MEMORANDUM

To: Sean Dundon, Chair, and Members of the Portland Planning Board
From: Nell Donaldson, Senior Planner
Date: February 9, 2018
Re: 56 Parris Street, Parris Terraces
Project #: 2017-287 **CBL:** 33-A-13
Meeting Date: February 13, 2018

Figures 1, 2, and 3 (from top left): 56 Parris zoning context; 56 Parris site; preliminary site plan

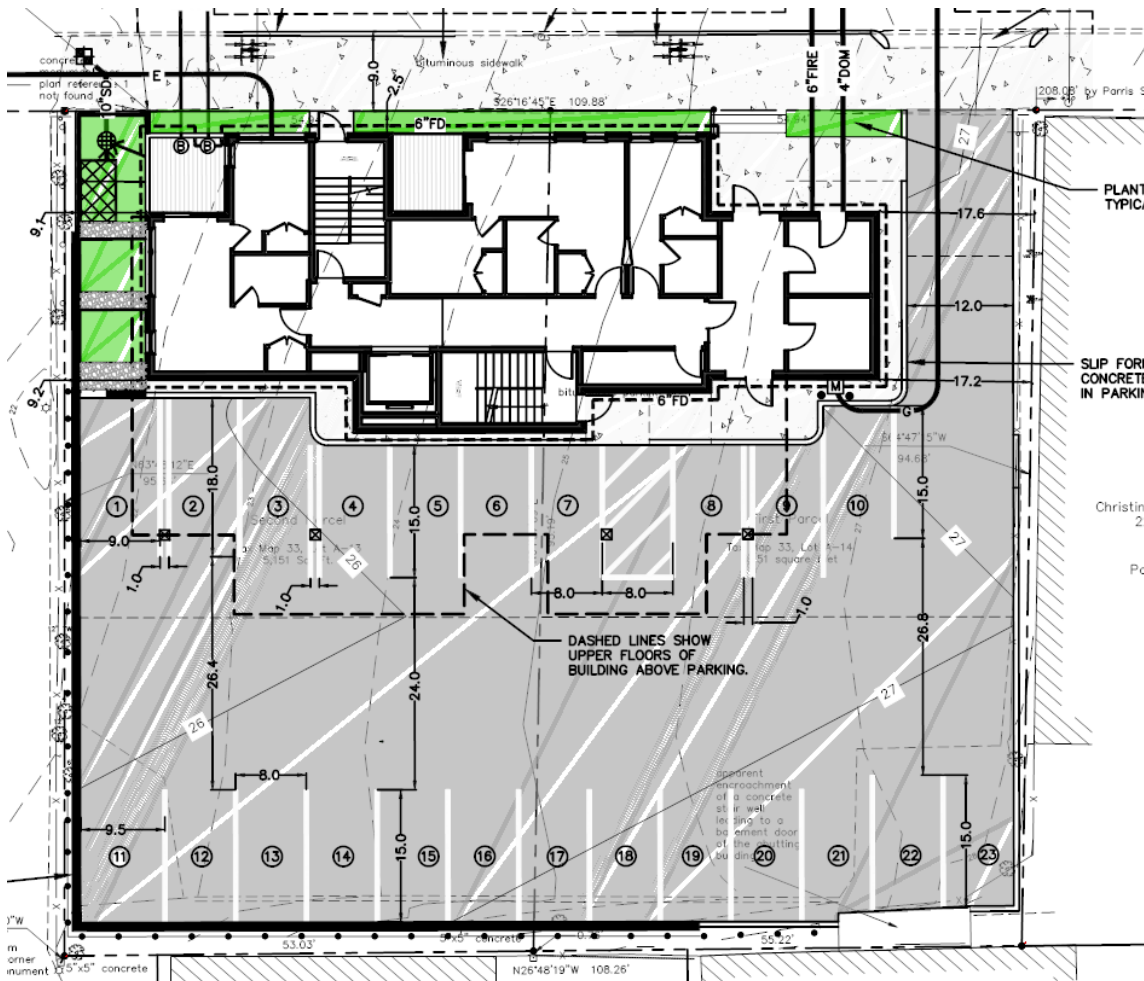
The applicant has proposed one 12' driveway at the southern end of the site as means of vehicular access to the parking area at the site's rear. Staff has consulted with the applicant on the width of this driveway, noting that it is insufficient to meet fire access standards, and the applicant is currently working on plans to expand the width of the driveway. Mr. Errico has reviewed the vehicular access and writes,

It is my understanding that the driveway is being widened to 16-feet per Fire Department comments. I will review the revised plan when provided. In general, I support a waiver from City standards given, low trip generation to and from the site and low traffic volumes on Parris Street.

The preliminary plans show that a significant number of the 23 spaces are designed as compact spaces. Staff has requested that in the final submittal, the applicant document the number of compact and standard parking spaces with dimensioned drawings. On this point, Mr. Errico writes,

The project is proposing a significant number of compact parking spaces and thus does not comply with City standards. I will be conducting informal observations at existing similar sites to assess likely vehicle size characteristics. I will also provide comments regarding on-site vehicle circulation at that time.

The applicant has submitted a conceptual landscape plan with the preliminary submittal. The plan includes ornamental grasses at the sidewalk, a rain garden at the northeast corner of the site, and a fence with vines around the northern, western, and southern property lines. Jeff Tarling, the City Arborist, has reviewed the plan and writes,

The proposed 56 Paris Street project appears to use 98% of their lot building with a small percentage for dedicated tree and landscape. This is one of the very few residential projects we have seen with zero trees, perhaps additional trees could be planted nearby with the contribution to the Tree Fund.

Given the building mass stays the same we would ask if additional landscape elements could be introduced to add some variety. This would include taking a second look at the proposed 'planters with grasses' to see if any woody plants (shrubs) could be introduced. The same for the rain garden area, these are places where some additional tree or landscaping could be shown.

Overall we would ask for more details on the landscape and trees, it is disappointing to think of new residential construction with minimal thought of greening as an important element of design. The rain garden / snow storage has some potential in this regard. It would be good to have an actual plant list with the final plan stating the type and size of the landscape plant stock. Good to have additional information on the proposed fence with vines types as well.

A retaining wall is proposed around a portion of the site. No details have been provided. Please note that a geotechnical evaluation of soil types and soil bearing capacities is required for retaining walls over three feet in height.

No stormdrain infrastructure is proposed within the parking lot. Additional spot grades should be provided to further show drainage intent.

The plans should note a location for snow storage or a snow removal plan should be described. The snow storage location should be sited outside of existing and proposed drainage courses.

Robert Thompson, of the city's Fire Prevention Bureau, has reviewed the plans and has raised concerns regarding the width of the proposed driveway. He writes,

Access to the rear of the building must be a minimum of 16'.

As noted above, the applicant is in the process of modifying plans to address this comment.
